SITE PLAN
SCALE 1"=30'

NO. BRUNSWICK PLAN REVIEW
APPROVED
JAN 04 1989
as noted
SPRINKLER LOCATIONS

PERMIT: 15361
LDS NB 10304650

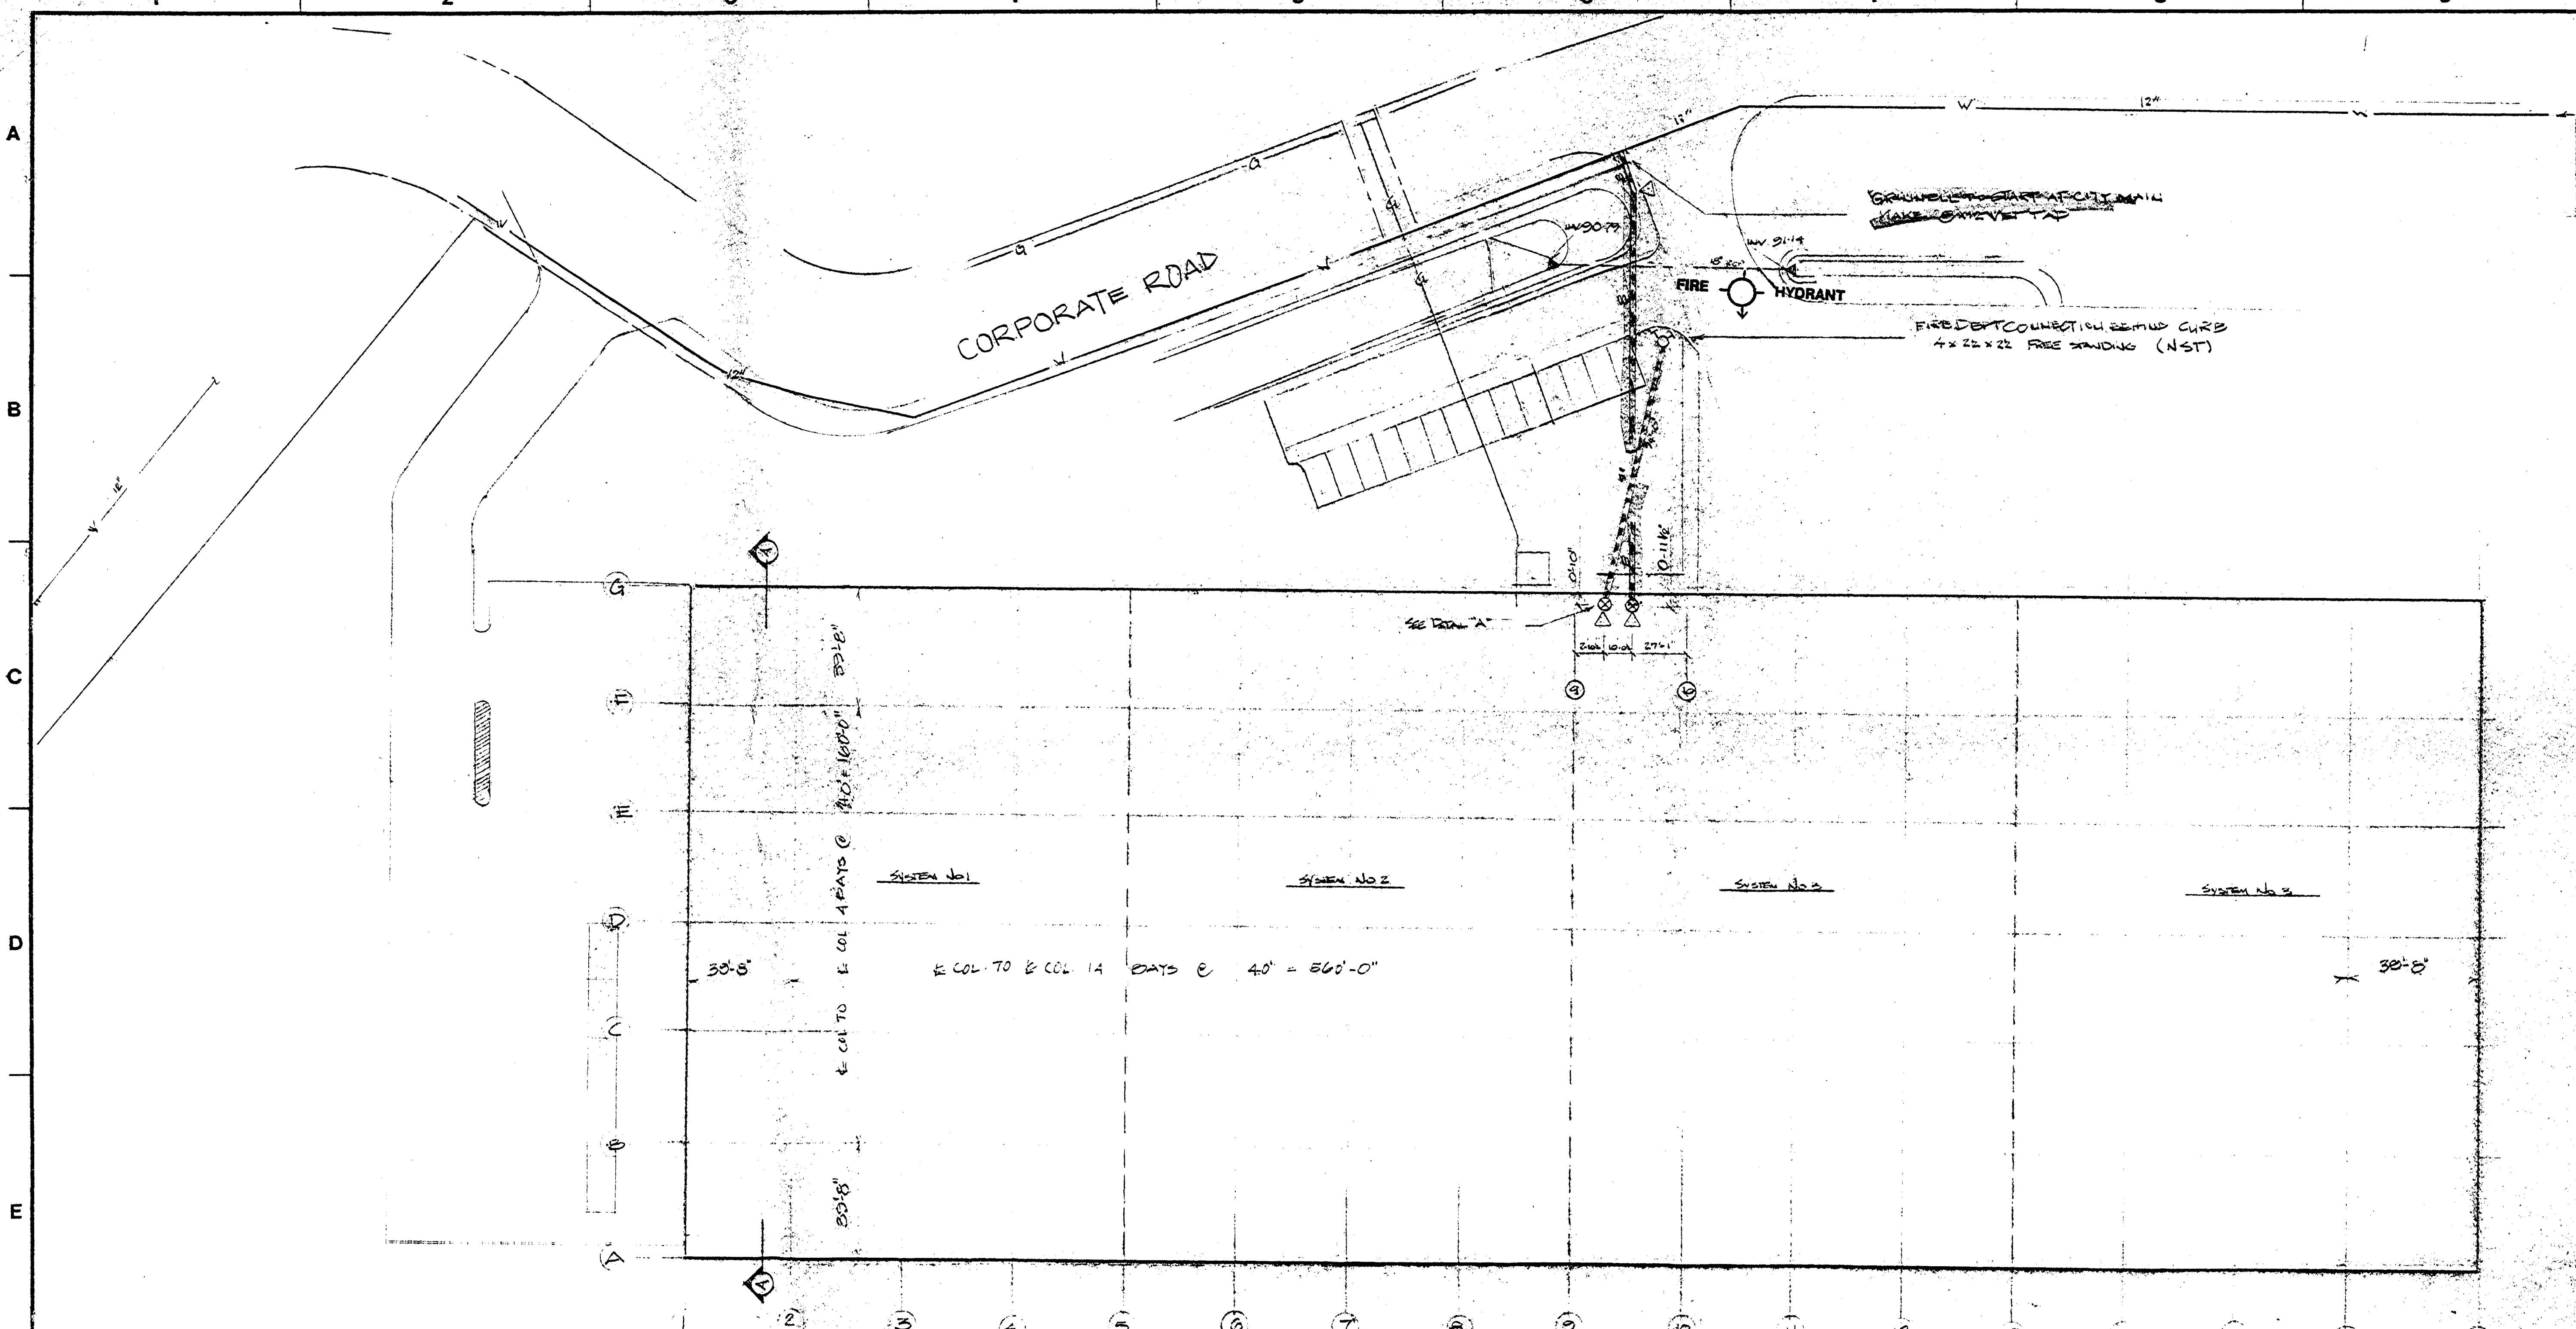
PLAN REVIEW
APPROVED FOR CONSTRUCTION
FOR FIRE HYDRANTS &
WATER MAIN LOCATIONS

① Installation must comply NFPA 13
1987 BOC A 1014.0 / 1020.0

PLAN APPROVAL IS COMPLIANCE
WITH THIS NOTATION OF THIS PLAN
IS AN INTEGRAL PART OF THIS PLAN
